PALISADES NUCLEAR GENERATING PLANT

Amendment No. 6  
License No. DPR-20

SAFETY EVALUATION BY THE DIRECTORATE OF LICENSING

MODIFICATION TO THE LIQUID RADWASTE SYSTEM

Figure 4-11.1 Locations of climatological stations

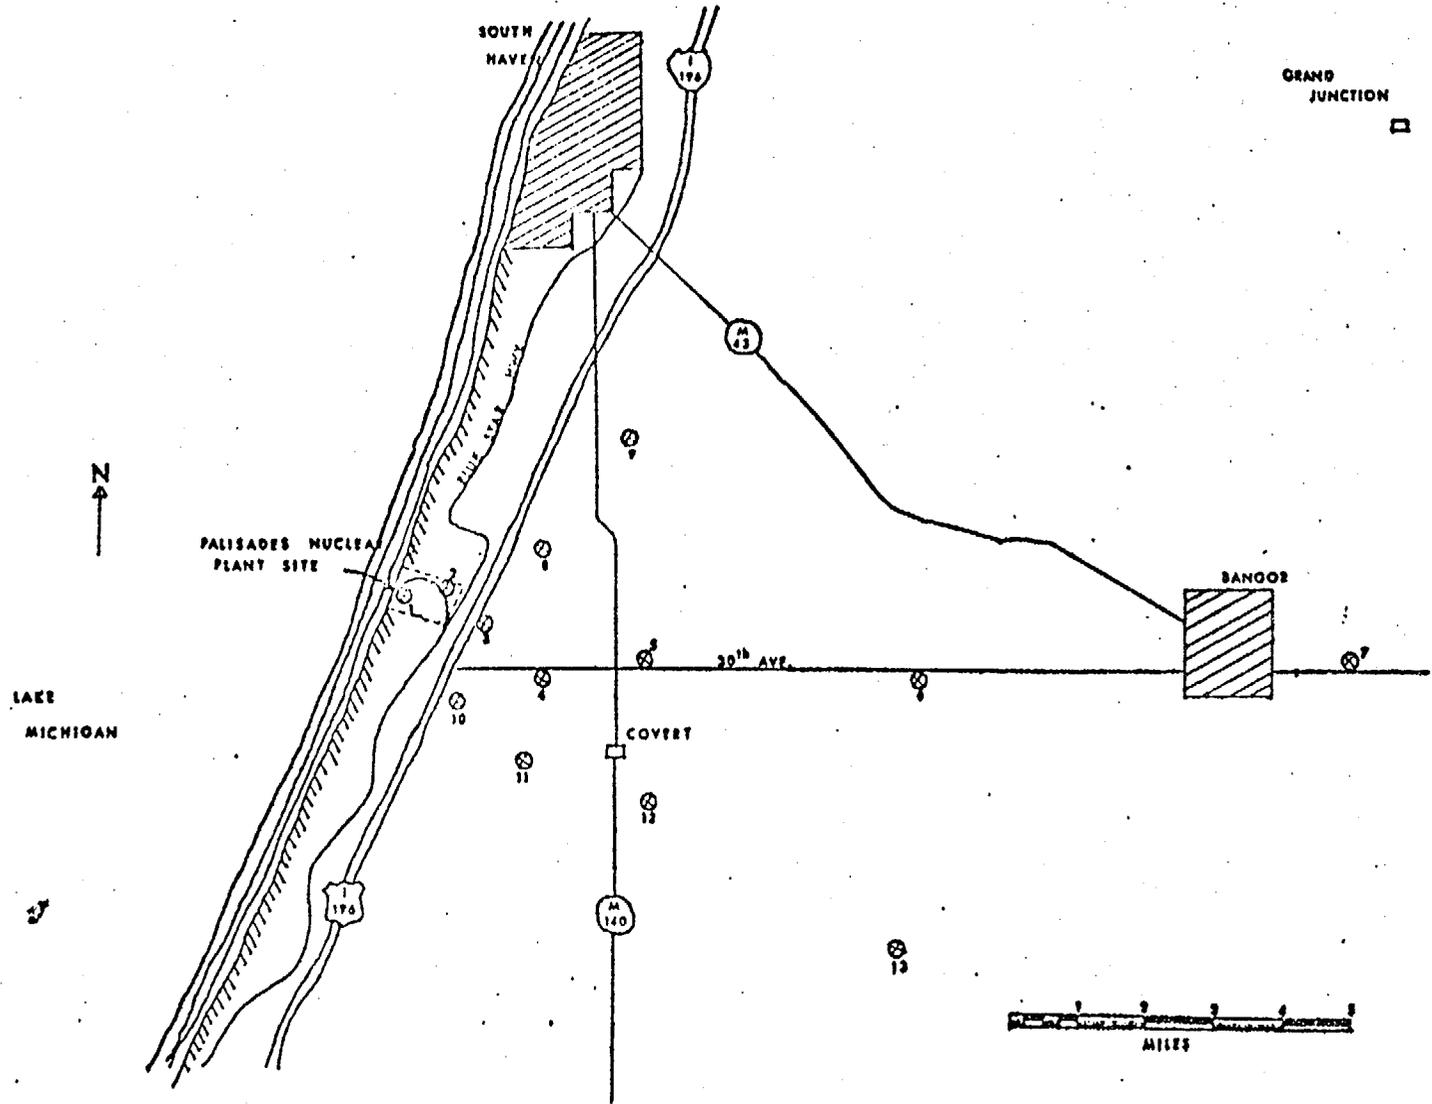
4.11.6 A meteorological monitoring program<sup>(2)</sup> shall be conducted in the vicinity of the plant site for at least two years after conversion to cooling towers to document effects of cooling tower operation on meteorological variables. Data on the following meteorological variables shall be obtained from the station network shown in Figure 4.11.1: Precipitation, temperature, humidity, solar radiation, downcoming radiation, icing conditions, visibility, wind direction and wind speed. In addition, studies shall be conducted for at least two years to measure effects of cooling tower drift on vegetation by associated salt deposition, icing or other causes.<sup>(3)</sup> Observations shall be made of a series of sample vegetation plots, and chemical analyses shall be made of representative samples of vegetation, soil and collected moisture to establish relative amounts of drift at various locations and influences on plant life. The incidence of icing and fogging on nearby transportation arteries shall be determined. Noise measurements shall be taken with and without the cooling tower in operation at different locations on site and around the surrounding areas. The study program to assess the meteorological and terrestrial effects of cooling tower operation onsite and offsite shall be carried out as follows:

Figure 4.11.2

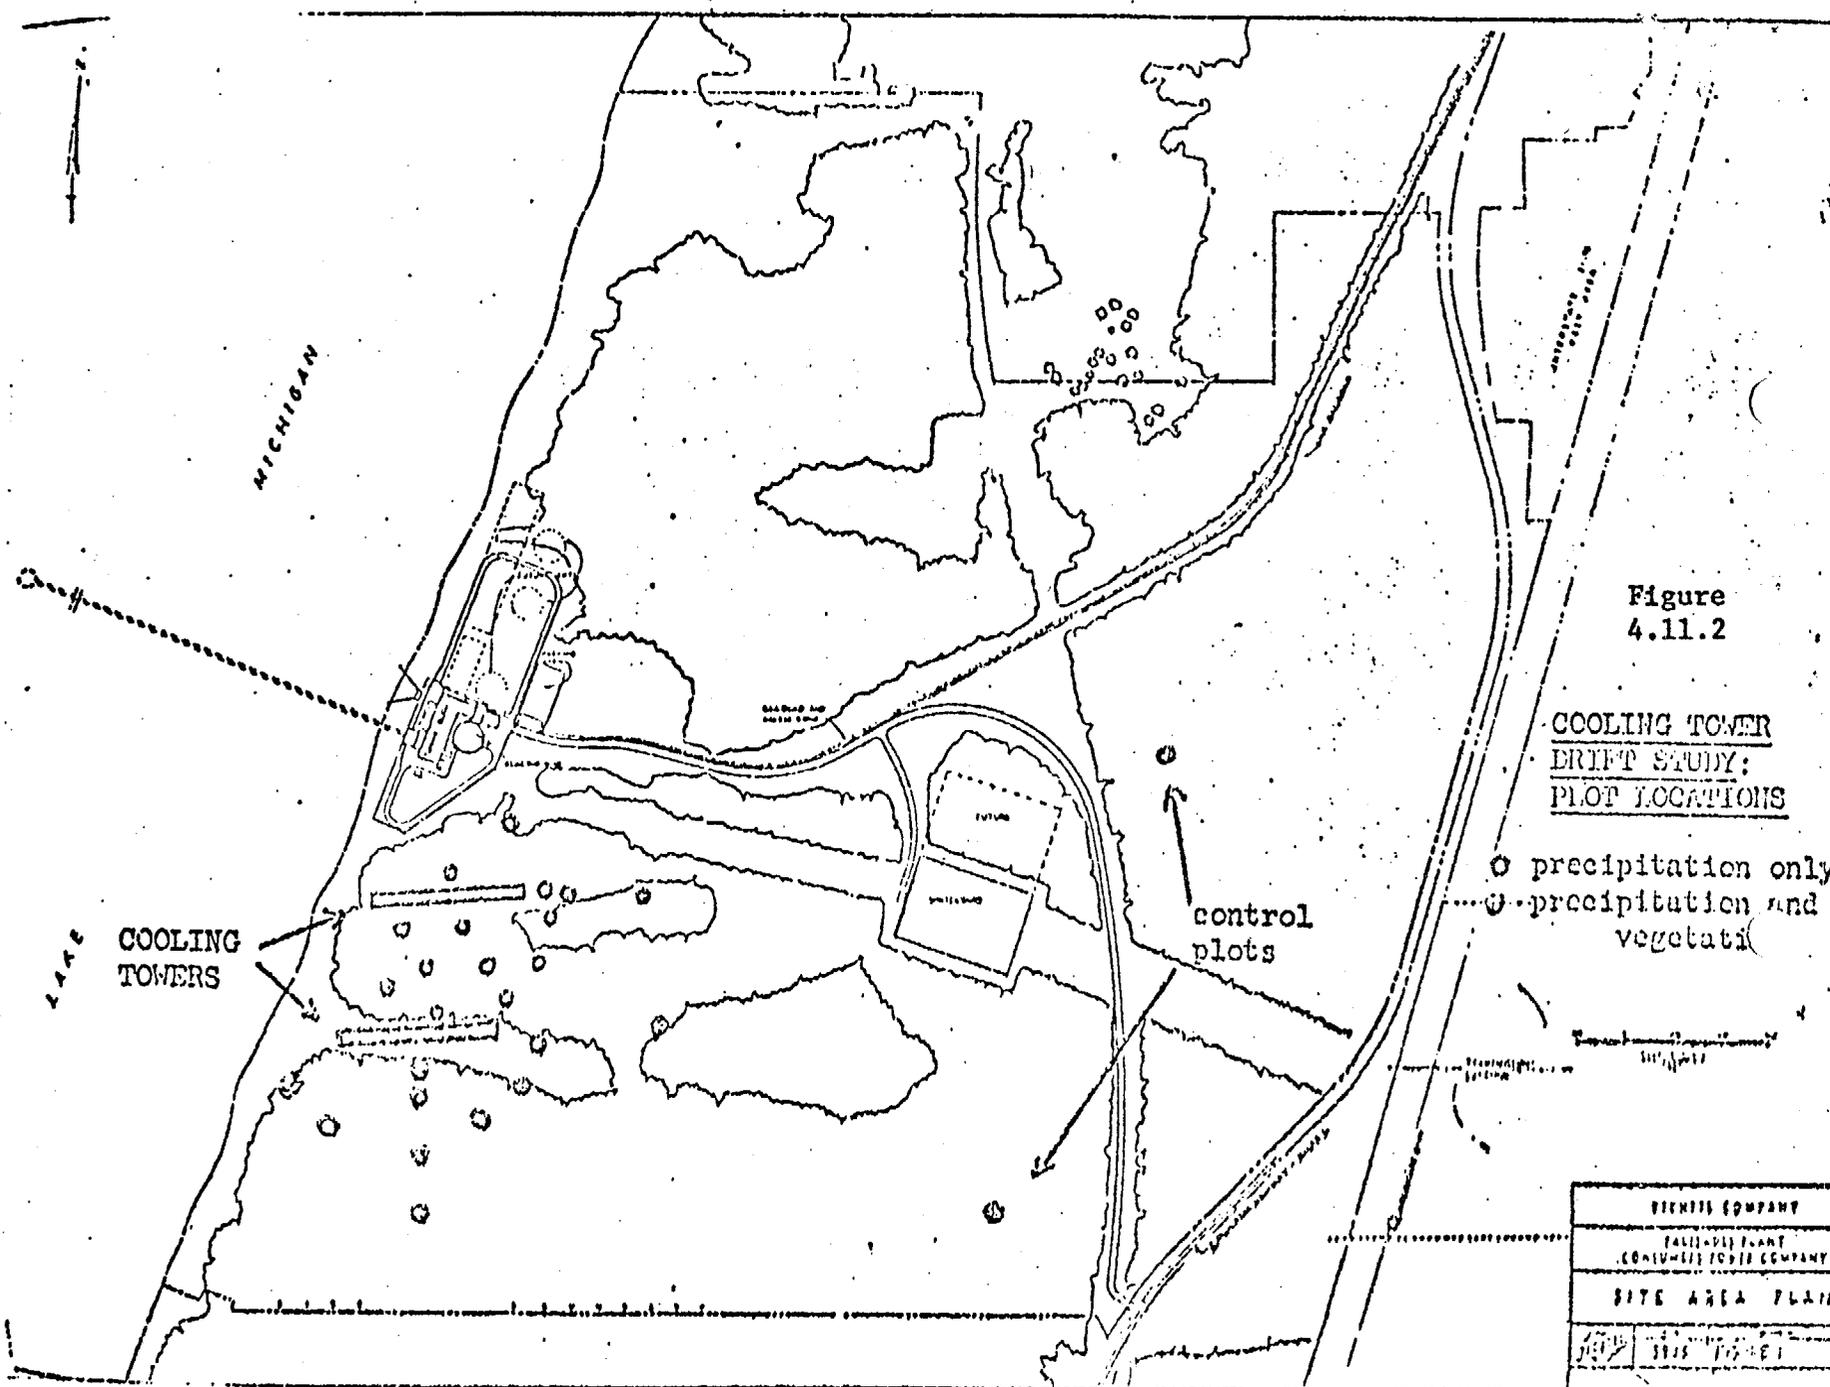
The licensee also plans to conduct studies for at least two years to measure effects of the cooling tower drift on vegetation by associated salt deposition, icing, or other causes. Observations shall be made of a series of sample vegetation plots, and chemical analysis will be made of representative samples of vegetation, soil, and collected moisture to establish relative amounts of drift at various locations and influences on plant life. The staff has recommended that total soluble salt deposition, including sulfate ion, be measured as a function of time at the proposed sampling stations. Concentrations of salts from the biocides used should be determined in the drift collectors.

FIG 10-8

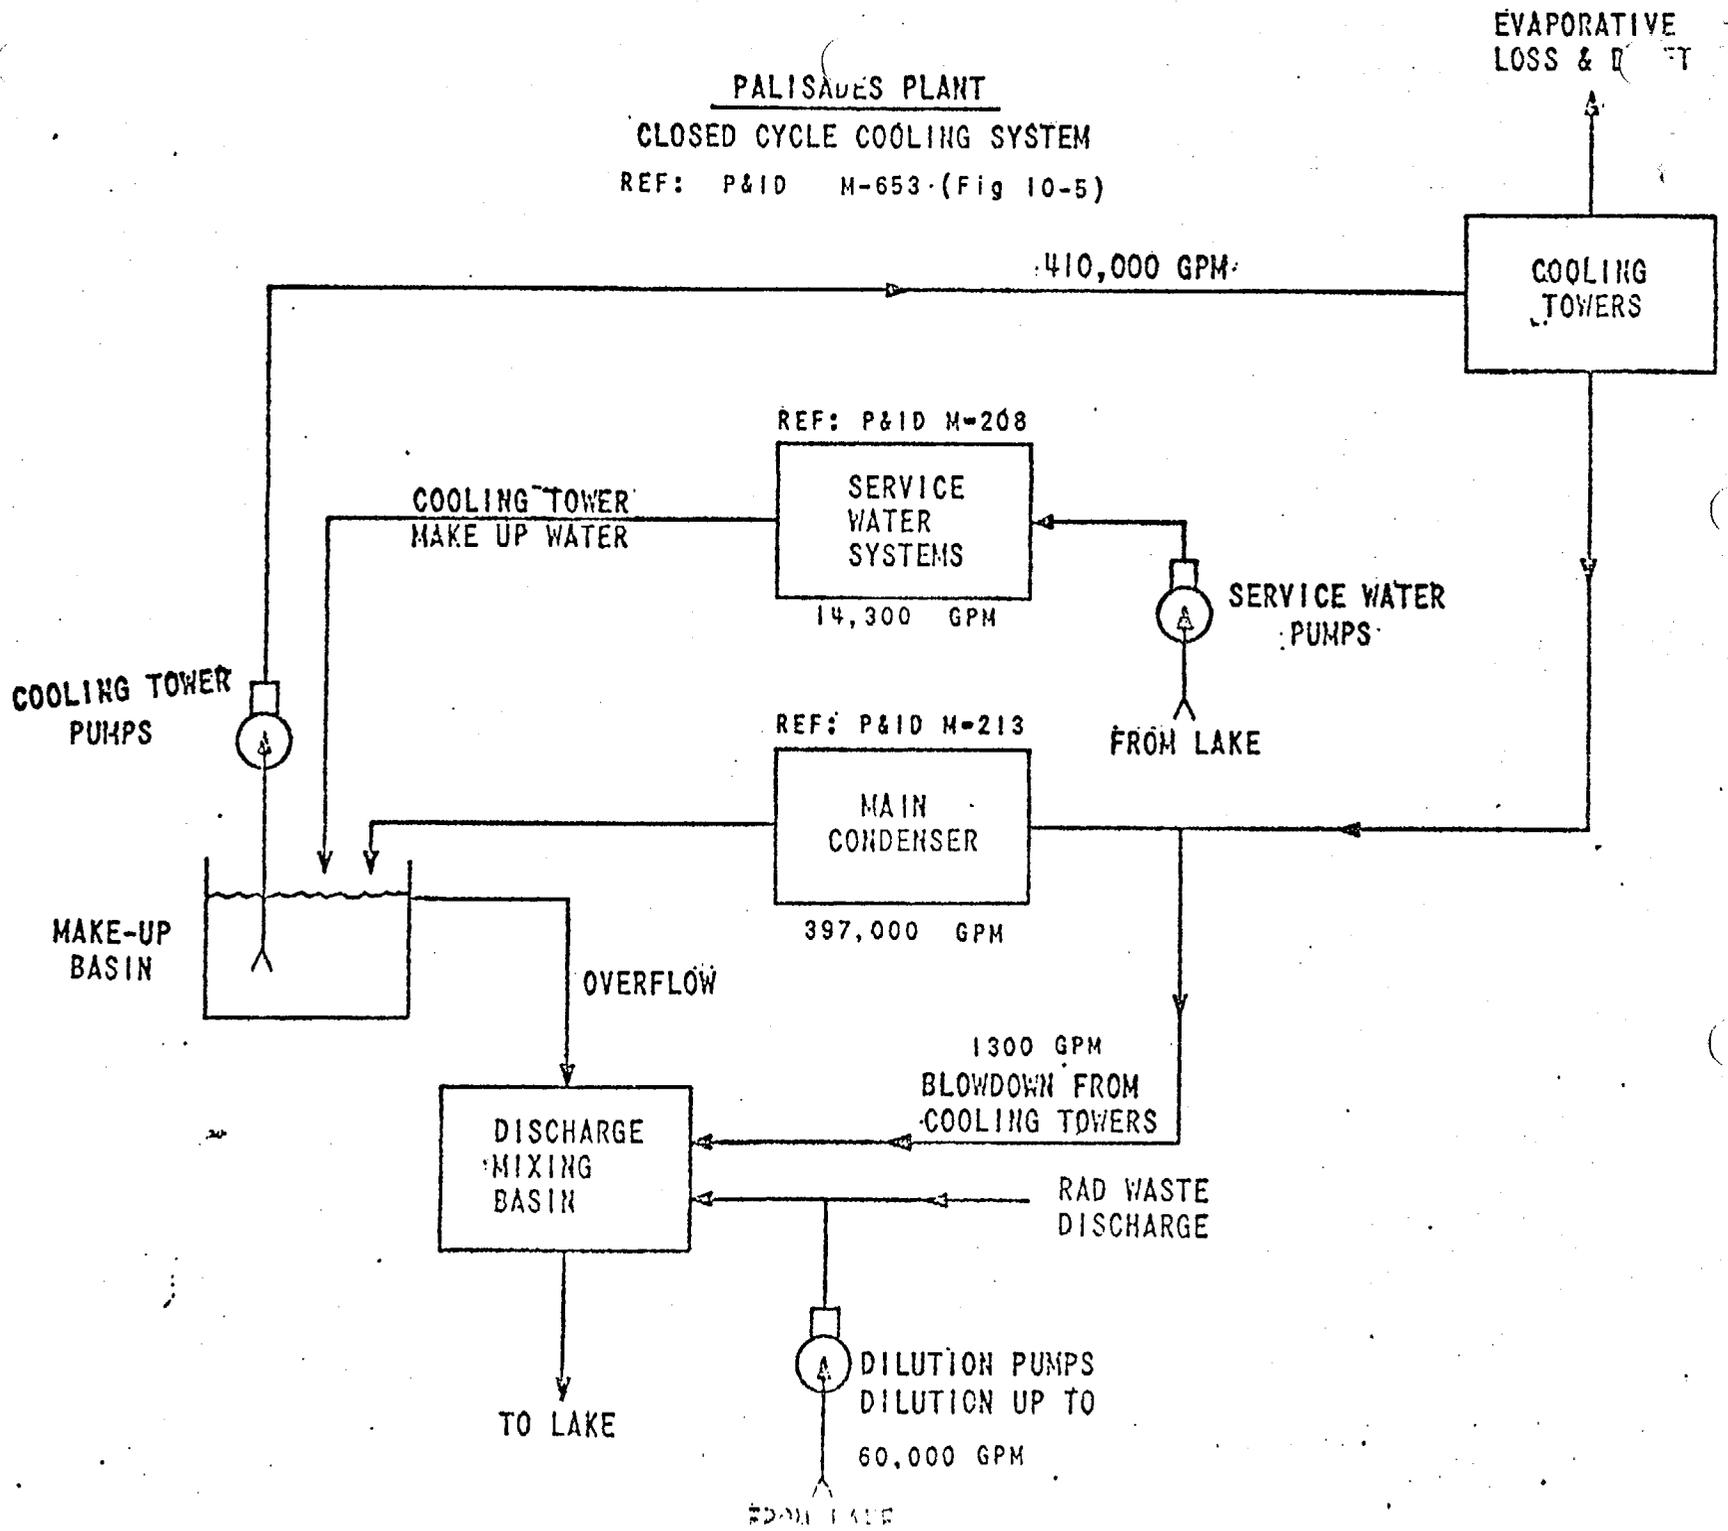
According to Figure 10-8, any radioactive wastes released will be collected in the discharge mixing basin after being monitored, diluted with lake water and cooling tower blowdown, and discharged over a weir into the discharge canal. Because of the low radioactivity levels in
